Agenda Item # 7

SUB-003439-2025

Tamberlyn Park at Downtown North Subdivision

APPLICATION NUMBER 7 DATE September 18, 2025

DETAIL SITE PLAN

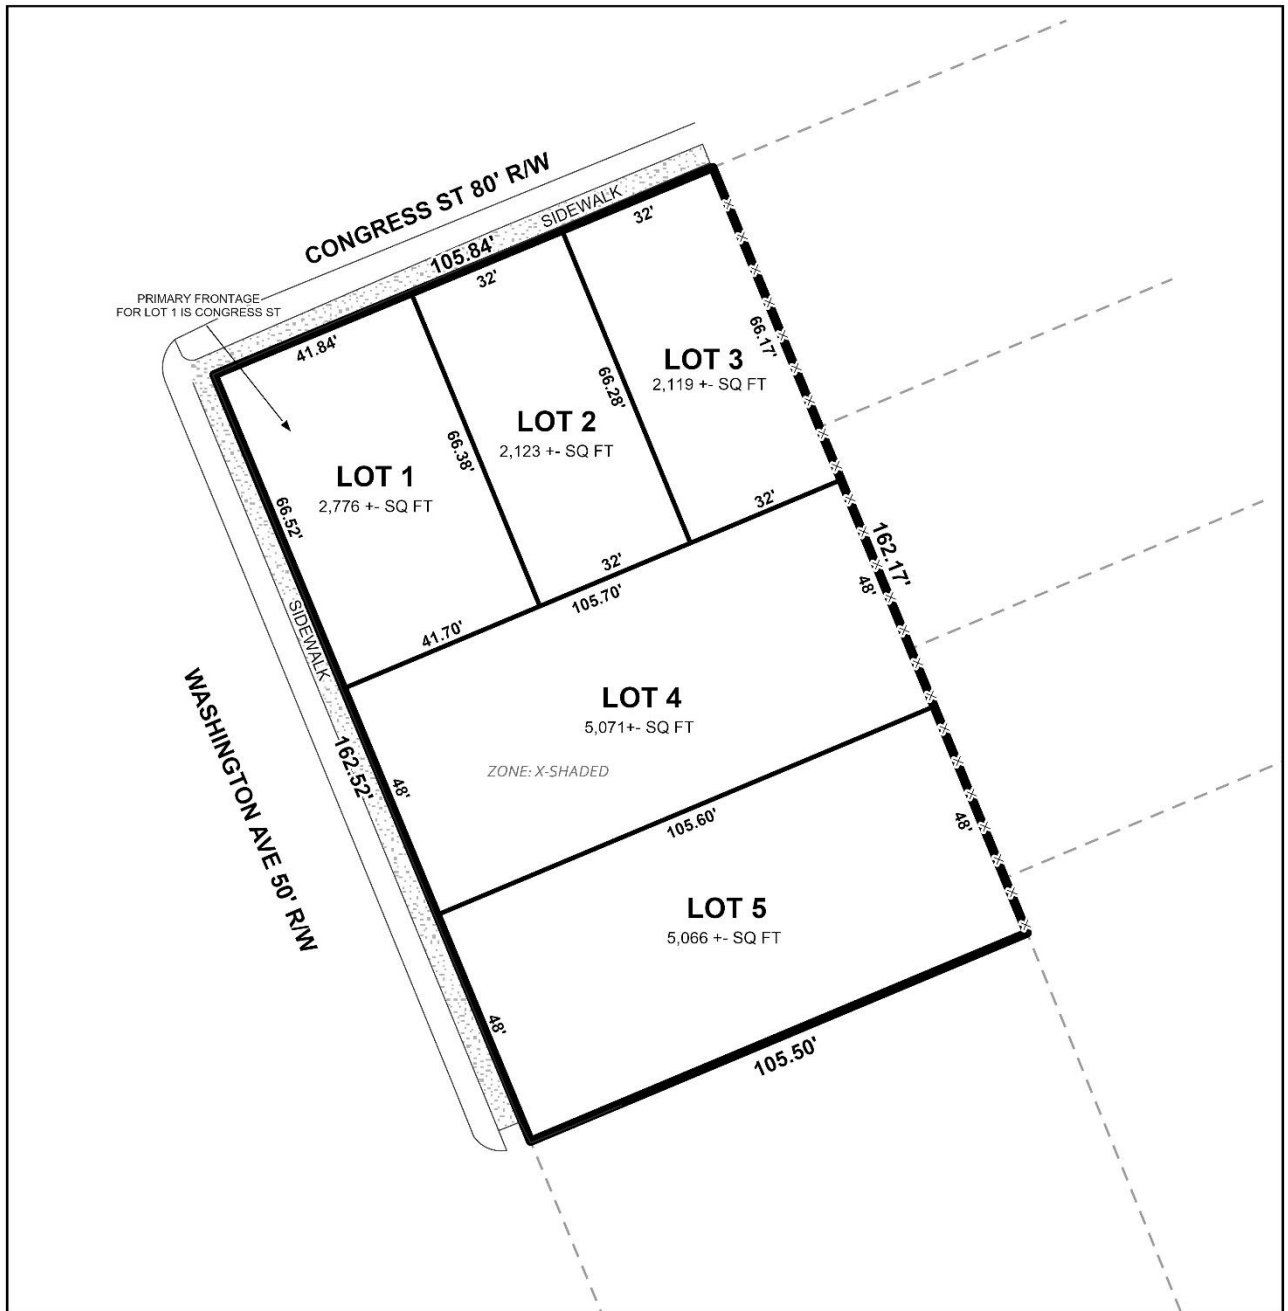
- B. Review and revise the written legal description to include a distance for the east property line.
- C. Delete NOTE 7 and insert the following: "As shown on the 1984 aerial photo LOTS 1 - 5 will share the 9,000 SF historical credit of existing (1984) impervious area towards stormwater detention requirement per Mobile City Code, Chapter 17, Storm Water Management and Flood Control) and share the 4,000 SF credit provided to the original lot as follows: LOT 1 – 2,600 SF, LOT 2 – 2,600 SF, LOT 3 – 2,600 SF, LOT 4 – 2,600 SF, and LOT 5 – 2,600 SF.

Properties located within a T-4 sub-district are allowed a 12-foot maximum setback along street frontages. If approved, the maximum setback line should be depicted on the Final Plat.

The subject site is currently undeveloped. The DDD requires parking to be accessed from a secondary frontage where available. A note stating this should be placed on the Final Plat, if approved. As the proposed Lot 1 will have frontage along both Congress Street and Washington Avenue, both of which are "B" streets, the preliminary plat has a note stating that Congress Street will be its primary frontage. If approved, this note should be retained on the Final Plat.

It should be noted that T-4 lots that are less than 42-feet wide, and do not have a secondary frontage available, are not allowed a curb cut. As such, if approved, a note should be placed on the Final Plat stating that Lots 2 & 3 are not allowed to have a curb cut.

1. Dedication of the corner radius at the intersection of Congress Street and Washington Avenue, if deemed necessary and appropriate by the Engineering Department;

2. Retention of the existing right-of-way along all street frontages;
3. Depiction of the 12-foot maximum setback along all street frontages, adjusted for dedication, if any;

4. Retention of the lot sizes in both square feet and acres, or the furnishing of a table on the Final Plat providing the same information, adjusted for dedication, if any;

5. Retention of the note identifying Congress Street as the primary frontage for Lot 1;
6. Placement of a note stating that Lots 2 & 3 are prohibited from having curb cuts;
